Docket Item #15

Development Special Use Permit #2013-0008

EESAP Blocks 11 & 12 Extension - 2210 Eisenhower Avenue

Purpose of Application
Approval of a three year extension for a previously approved Development Special Use Permit, DSUP #2009-0004 for two blocks in the <i>Eisenhower East Small Area Plan</i> area.

Illustrative F: Staff Alternate Ground Floor Plan - Expanded Retail Space shown in blue
 Note that retail elevator location gives direct access to Eisenhower Avenue and lease space.

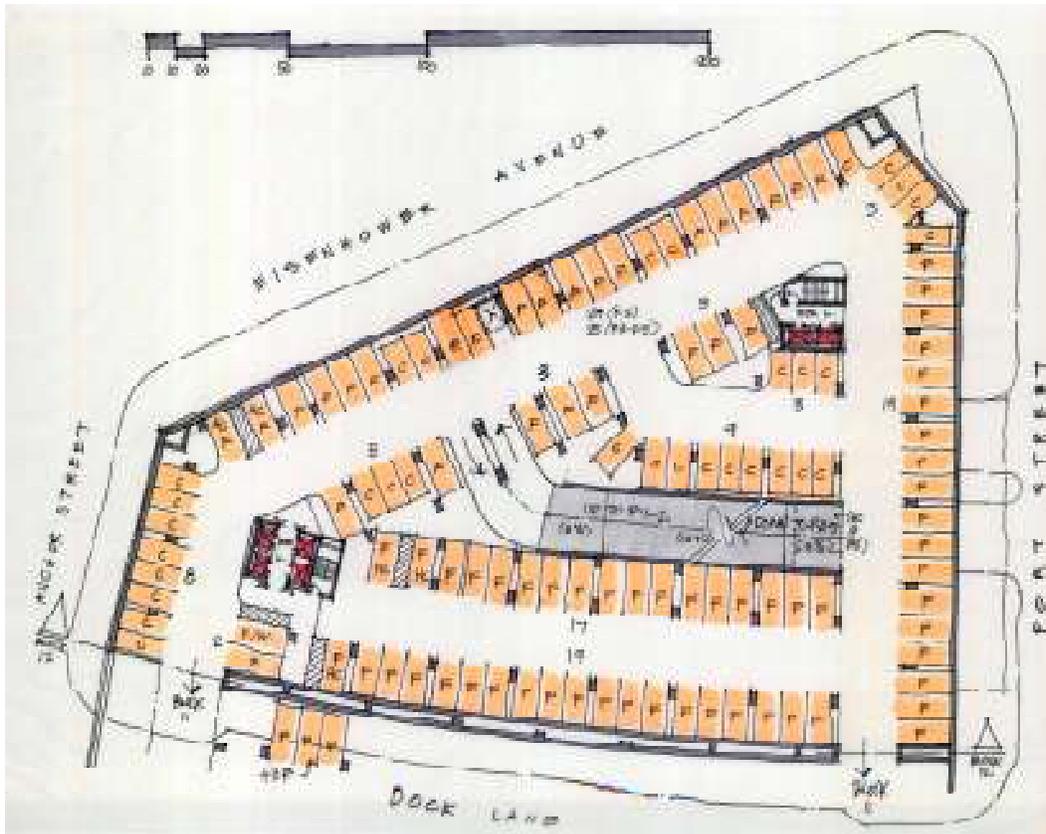
Staff has also consistently noted great inefficiency in the one on-grade and two above-grade sections of garage that have been shown for combined retail and residential parking on Block 12. Using the applicant’s own area calculations, these three, very small and irregularly shaped garage plates park a total of only 96 cars in 68,000 SF. This means that each parking space in this garage takes up more than 700 square feet, compared to an industry standard of around 350 SF/car. Staff has studied an alternate design (see illustrations, below), which considers the redesign of entry, aisle and circulation geometry in the five levels of garage *below Block 12 only*. Staff studies showed that the increased efficiency could accommodate all of the cars currently shown parked above-grade on Block 12 *and* allow removal of all 68,000 SF of above-grade garage (a building area comparable to *two* Charles Houston Recreation Centers.) This design change would also consolidate all of the retail parking for Block 12 on a single level, with a simple one story elevator connection to grade and the retail space along Eisenhower Avenue. It permits the creation of more than a third of an acre of high-quality, south-facing public open space on Dock Lane, (comparable in size to Hunter-Miller Park,) while still saving the applicant a substantial amount of construction cost. This park could include high-quality outdoor dining

opportunities for future restaurants in Block 12, and is also large enough to accommodate retail kiosks, such as the ones found in Bryant Park and elsewhere in Manhattan. The plan changes also allow for greater retail depth (an industry-standard 70-80 feet, versus the 50 feet shown in the current proposal,) and the elevator location – close to Eisenhower Avenue - allows for complete flexibility in retail tenant sizes (versus the current proposal, which requires a passageway at some point, cutting the retail space in half.) This consolidated retail space gains substantial exposure as well, since it would also be visible *and* accessible from the newly-created open space, and its single parking entrance on Port Street is immediately visible to anyone coming to the retail, whether from Southern Street, Dock Lane or Eisenhower Avenue eastbound or westbound. Replacing the two ramps on Dock Lane with a single entry on Port Street also adds a significant number of on-street parallel parking spaces on Dock Lane (from 11 to 17.) Elimination of the above-grade parking structure also allows increased efficiency by relocating tenant and leasing office spaces currently shown on a single-loaded corridor on the second floor facing Port Street to the main building corridor, along with a net gain of 3 – 4 additional dwelling units, and elimination of an exit stair necessitated by the long dead-end corridor in the current proposal. Finally, removal of three levels of mechanically-ventilated garage would save total construction costs in the neighborhood of \$4 million. While these changes would involve some minor adjustments to column and core locations in Block 12, it should be noted that this piece of the project has been identified by the Applicant as Phase II, and there is therefore ample time to make these design changes without impacting the construction schedule for the overall project.

Illustrative I: Staff Alternate 2nd Floor Plan – Replaces Single-Loaded Condition with Double-Loaded

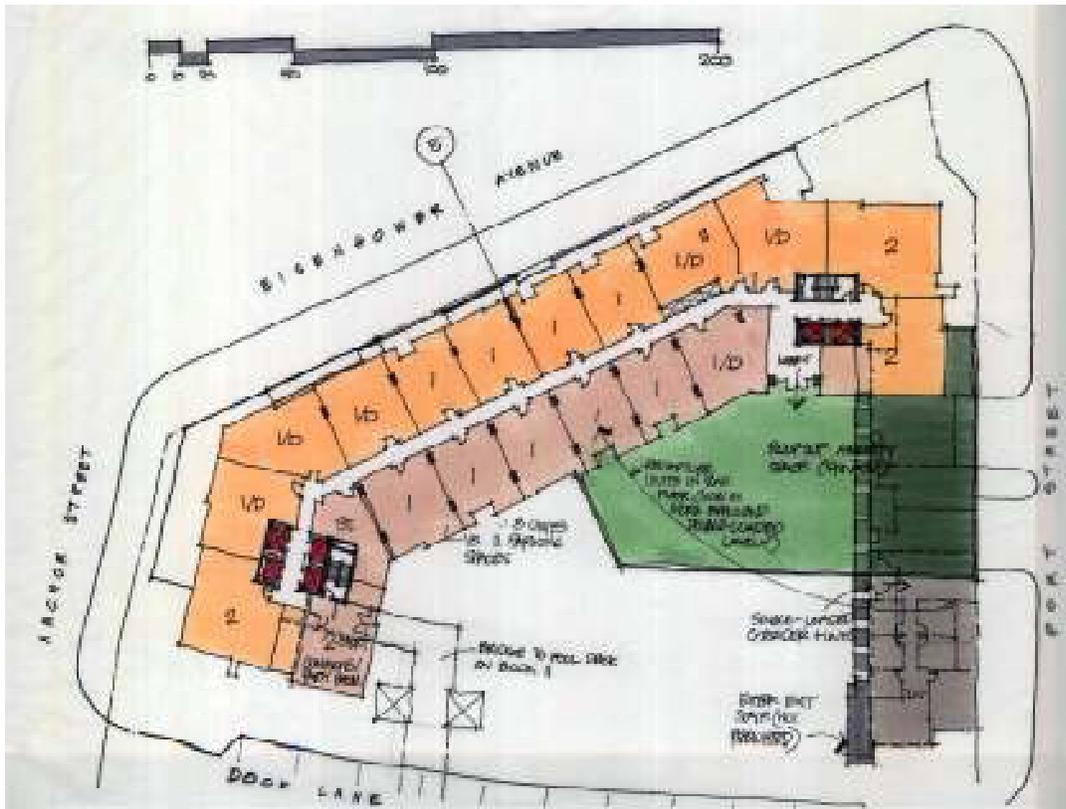
*) Applicant proposes a total of 95 cars on three above-grade levels - totaling approximately 65,000 square feet, which translates into \$3.5 to 5 million of construction. In

addition, this parking is very inefficient (over 750 square feet per car, versus a standard of around 350 square feet each.) The area freed up by elimination of the above-grade parking can provide over one-third of an acre of ground-level open space. The area on the 2nd floor formerly occupied by garage can then be used for additional residential units (yielding several additional units, and eliminating a redundant exit stair and long single-loaded corridor.)

***) Applicant proposes 53 retail spaces on two separate, small levels, which makes searching for a parking space difficult; staff proposal provides 54 retail spaces on a single level, with one-stop elevator connection to retail shops and Eisenhower Avenue.

ATTACHMENT D

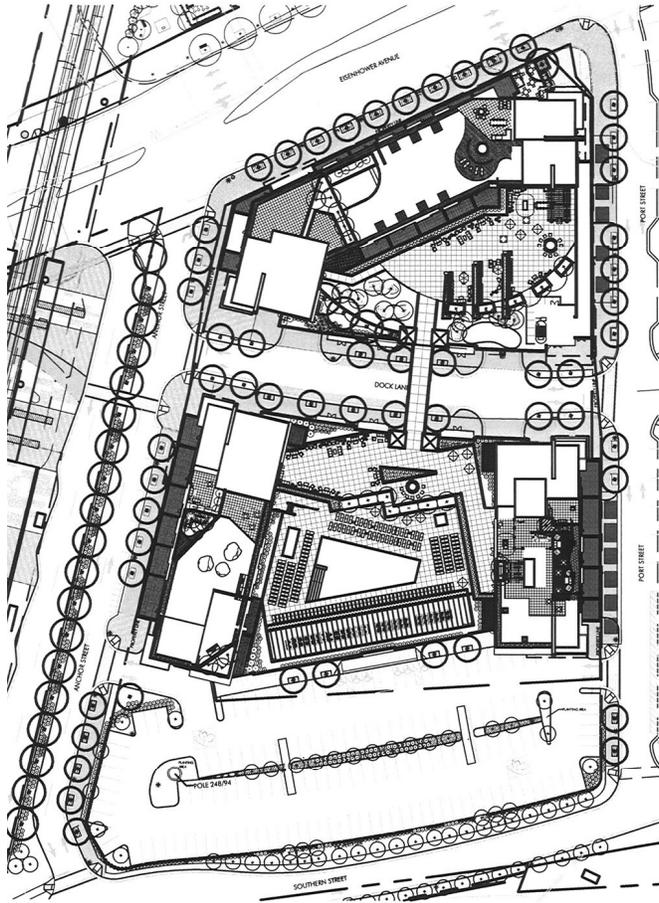
- a. Ensure all drawings are coordinated.
 - b. Provide a narrative demonstrating compliance with the open space requirements for the project.
 - c. Revise the crown coverage calculations in accordance with ATTACHMENT D.

ATTACHMENT E

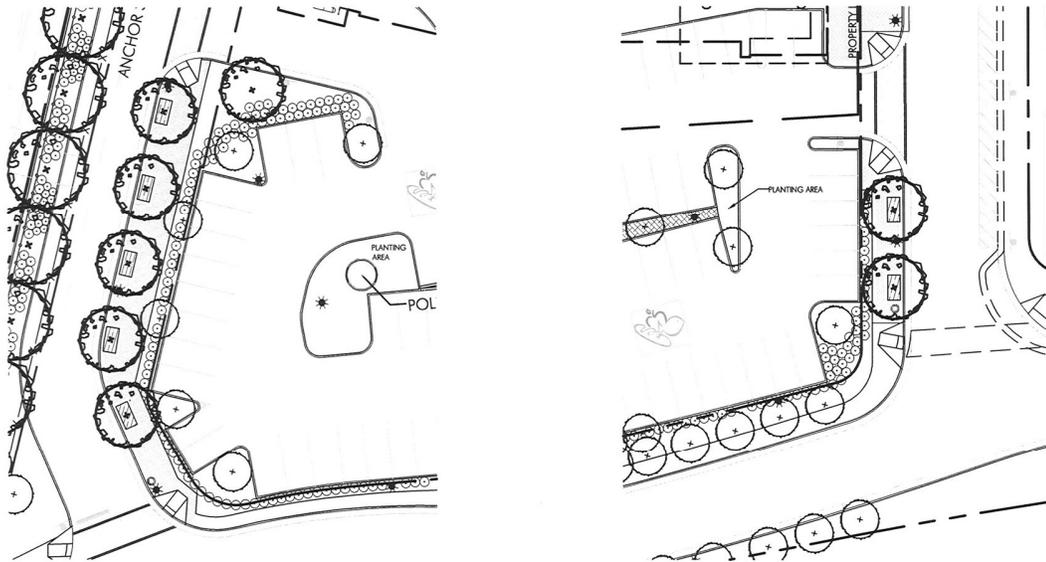
- a. Additional screening of the surface parking lot from view of public streets, particularly along Port and Anchor Streets, per ATTACHMENT E.
 - b. A maintenance plan for the flow through islands in the parking area. The plan shall include information on daily and long-term care, cleaning, and maintenance.
